TO: New Home
ATTN: Steven Kirby
PROJECT #: 21-2780-B (11-WB)
PAGE: 1 of 1
DATE: October 4, 2023
LOCATION: 359 Yates Mill Drive, Fuquay Varina NC
PLAN REF: Lot 11 Woodbridge South by New Home
 Project# 21-2780

THE FOLLOWING CHANGE(S) OR PROPOSED CHANGE(S) LISTED BELOW ARE DEVIATIONS OR CLARIFICATIONS FOR THE ABOVE REFERENCED PLANS:

OPT. FIREPLACE AT PATIO
 SCALE: 1/8"=1'-0" ON 11x17, 1/4"=1'-0" ON 22x34

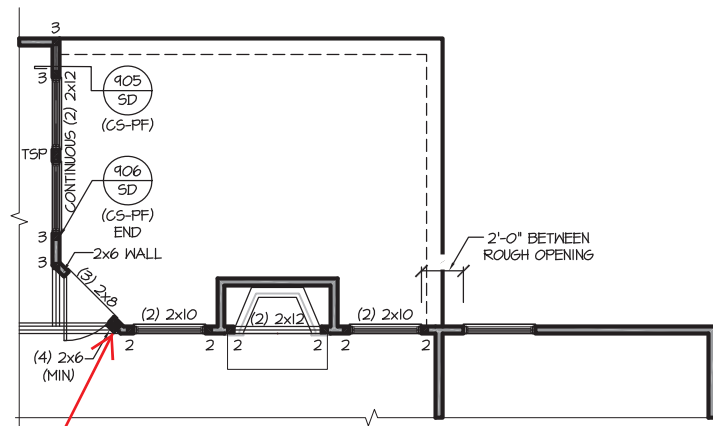
(3) 2X6 JACK STUDS AND
 SINGLE 2X6 KING STUD.
 ADDITIONAL 4 STUDS ADDED
 AT THE CORNER.
